# CITY OF ALBUQUERQUE

**RE: Family Dollar  
1400 Gibson Blvd SE  
Grading Plan  
Engineers Stamp Date: 3/9/18 (L15D049)**

**Re: Family Dollar 1400 Gibson Blvd SE- Grading Plan (L15D049)**

FAMILY DOLLAR STORE  
GRADING & DRAINAGE PLAN

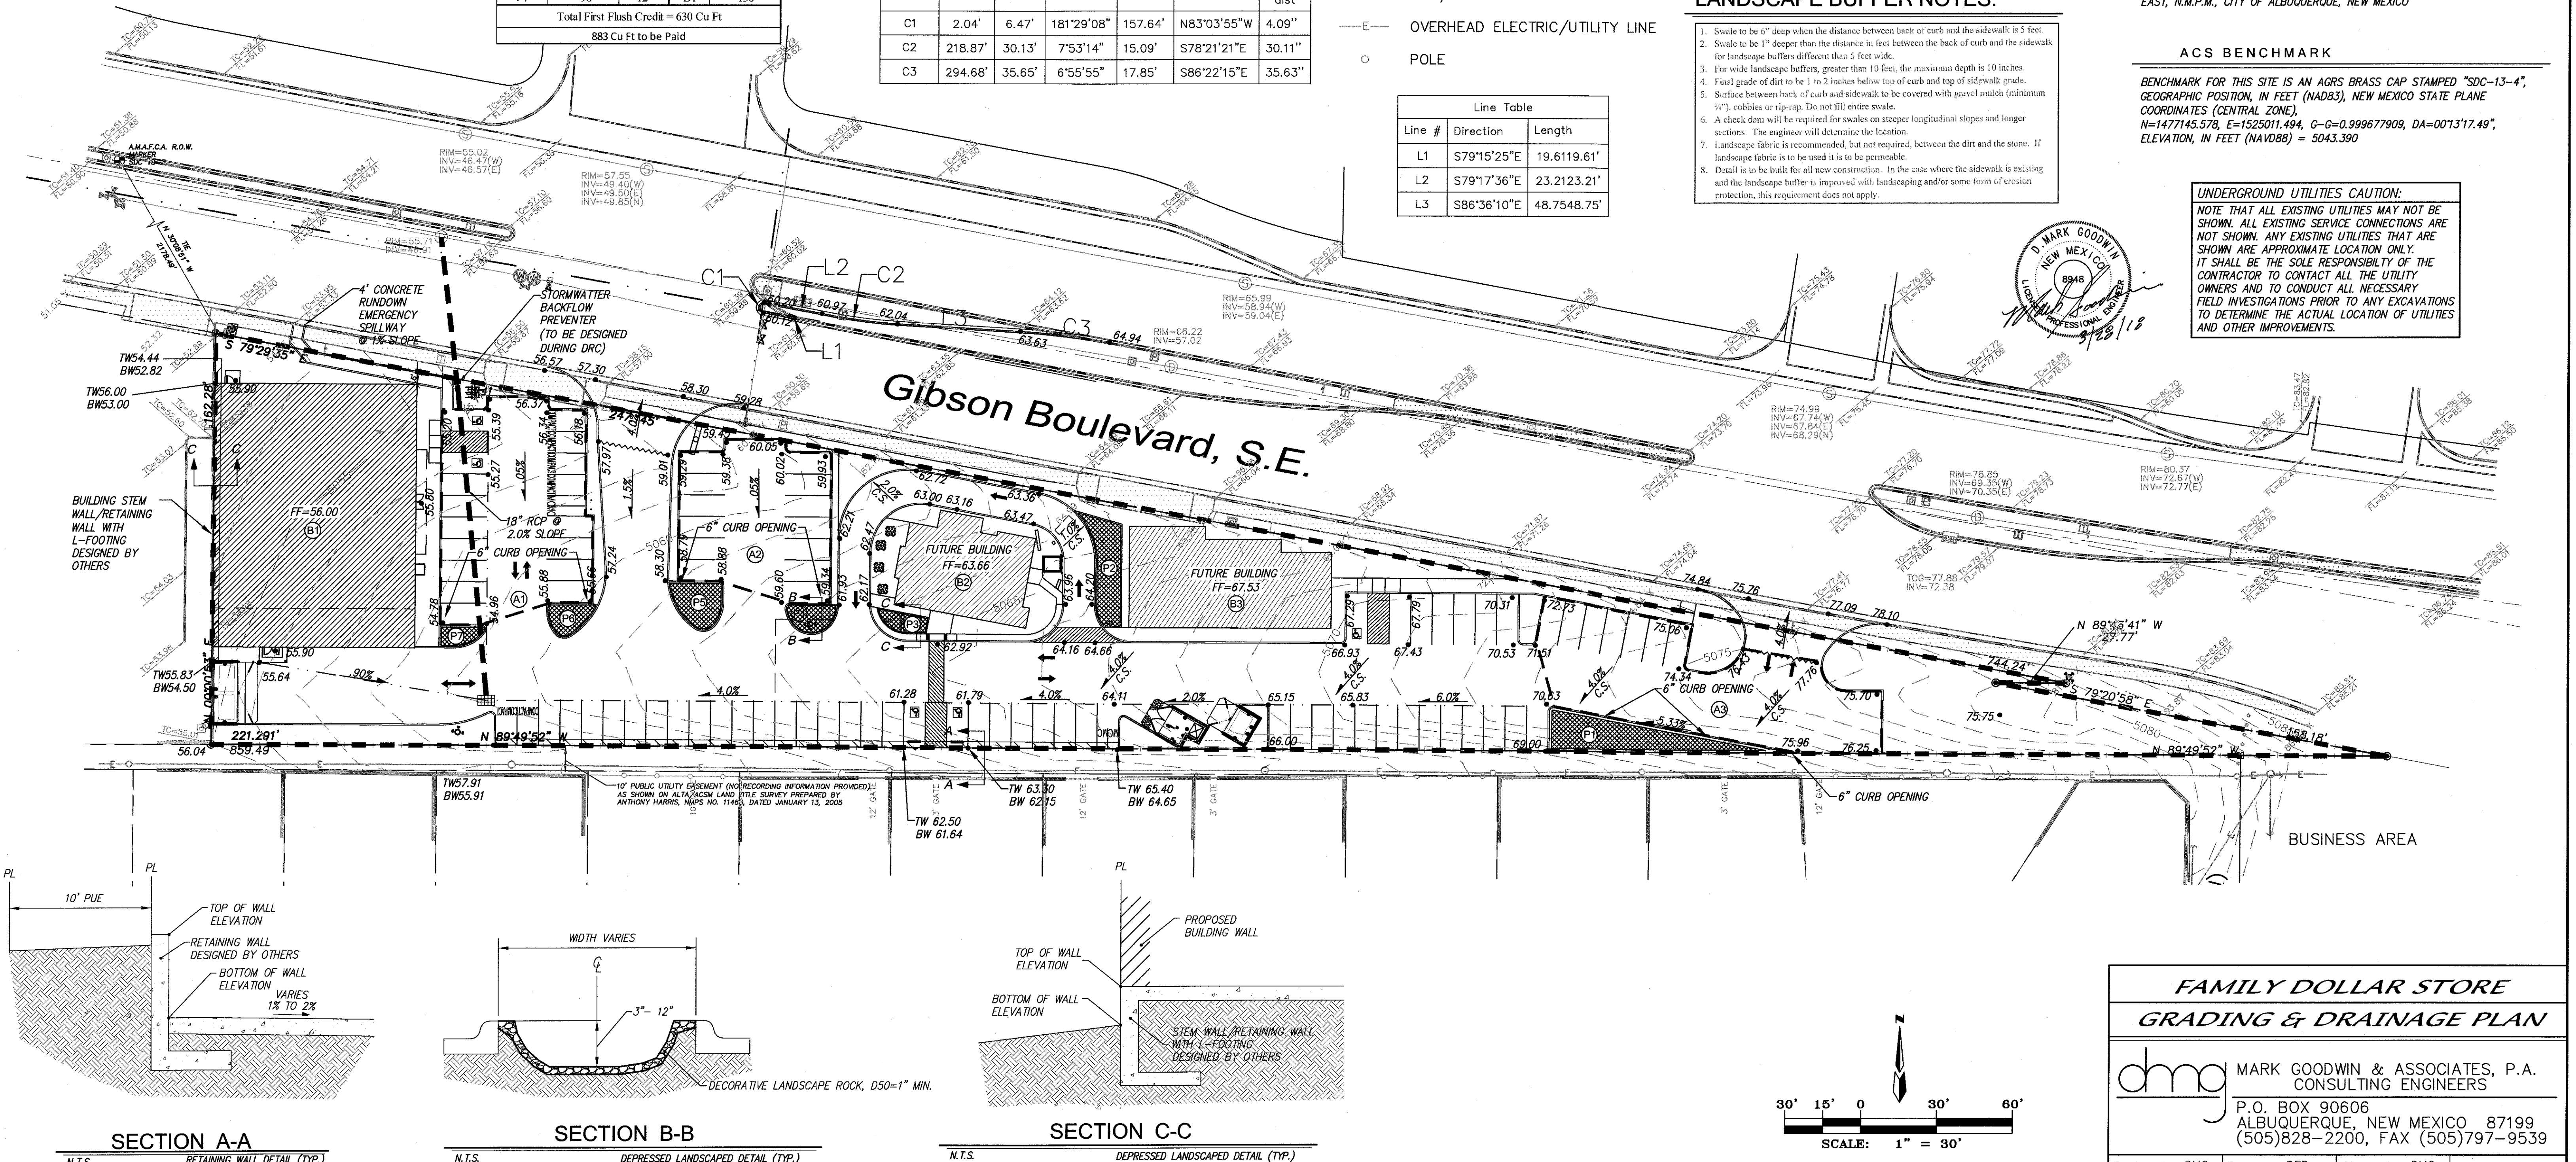
1. The backflow preventer will need to be designed. This will have to be a privately owned and maintained facility and cannot be pushed to DRC or be placed in the public ROW. A Private Drainage Covenant (no Public Easement) will need to accompany it and must be submitted to with the original notarized form, exhibit A (legible on 8.5x11 paper), and recording fee (\$25, payable to City of Albuquerque).

2. Clarification and additional detail is needed on the emergency spillway:
  - a. Increase the density of spot elevations and include top of curb/flowline elevations in the vicinity of the Family Dollar, correct the grade line from 0.05% to 0.5%, and provide the spillway elevation.

- b. Show the maximum water surface elevation and extents in the parking lot if the backflow preventer is engaged and water needs to pond in the parking lot.

- c. Provide a profile for the spillway channel (water surface, slopes, top/bottom of channel).
  - d. Provide a section for the channel showing the adjacent grades for the sidewalk, ROW, and Family Dollar. It seems there may be a drop-off from the back of sidewalk to the channel bottom and a pedestrian safety rail may be required.

- e. Build notes are needed for the channel as well (concrete type, thickness, reinforcement, etc.).
  - f. Include sidewalk culverts with capacity to pass 6.76cfs; these will be built by WO, but should at least be sized and shown on the grading plan.

3. Please put the build note for the private inlet back on the plan.
4. A Private Facility Drainage Covenant is required for the stormwater quality ponds. The original notarized form, exhibit A (legible on 8.5x11 paper), and recording fee (\$25, payable to City of Albuquerque) must be turned into DRC (4th, Plaza del Sol) for routing. Please contact Charlotte LaBadie (clabadie@cabq.gov, 924-3996) or Madeline Carruthers (mtafoya@cabq.gov, 924-3997) regarding the routing and recording process for covenants.

5. How do the roofs drain? Show on plans how they will be routed through the first flush basins.
6. Payment of the Fee in Lieu (Amount =  $883CF \times \$8/CF$ , per grading plan, stamped 3/28/18) for the required first flush volume must be made.

3. Storm water quality ponds and their associated drainage areas have been identified and marked on the plan. The bypass volume has been calculated to show the amount of 883 Cu ft. This would make the amount of First Flush to be Paid in leu at the amount of \$7064 (883 Cu Ft x \$8).

6. A section cut, and detail have been placed for the west property line to show the retaining wall with L-footing.
7. Work order plans have not been approved. A note has been added to the sheet stating "NO WORK ALLOWED IN THE PUBLIC RIGHT OF WAY WITHOUT AN APPROVED WORK ORDER."
